## SERVICE INSTRUCTION M20-108

SUBJECT: CIRCUIT BREAKER PANEL WIRING MODIFICATION AND INSPECTION OF ALTERNATOR WIRING

MODELS/ S/N M20J, 24-3000 THRU 24-3431; M20R, 29-0001 THRU 29-0288;  
AFFECTED: M20S, 30-0001 THRU 30-0064

FIGURE 1

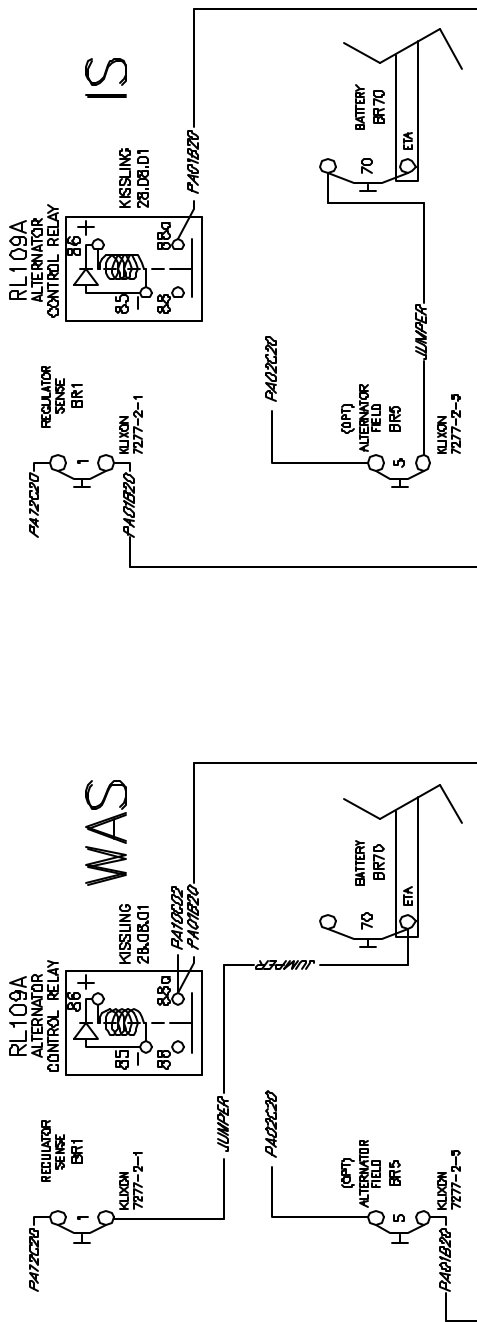
1. REF. APPROPRIATE MODEL'S SCHEMATIC [800383, REGION D-5]: CHANGE WIRING IN CIRCUIT BREAKER PANEL AS SHOWN IN FIGURE 1 BELOW.

FIGURE 2

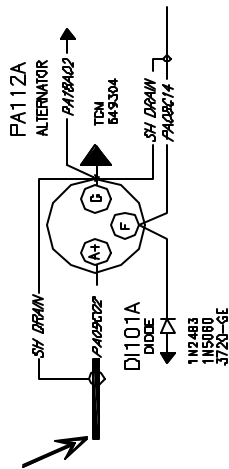
2. AT ALTERNATOR [SCHEMATIC 800383, REGION D-8] INSPECT WIRE PA09(X)02, SHIELD DRAIN TO ALTERNATOR CASE, FOR FRAYING/DAMAGE. REPAIR AS NECESSARY. COVER SHIELD DRAIN PIGTAIL WITH ANTI-CHAFING PROTECTION SUITABLE FOR THAT ENVIRONMENT, I.E. SPIRAL WRAP OR EQUIVALENT ANTI-CHAFF WRAP.
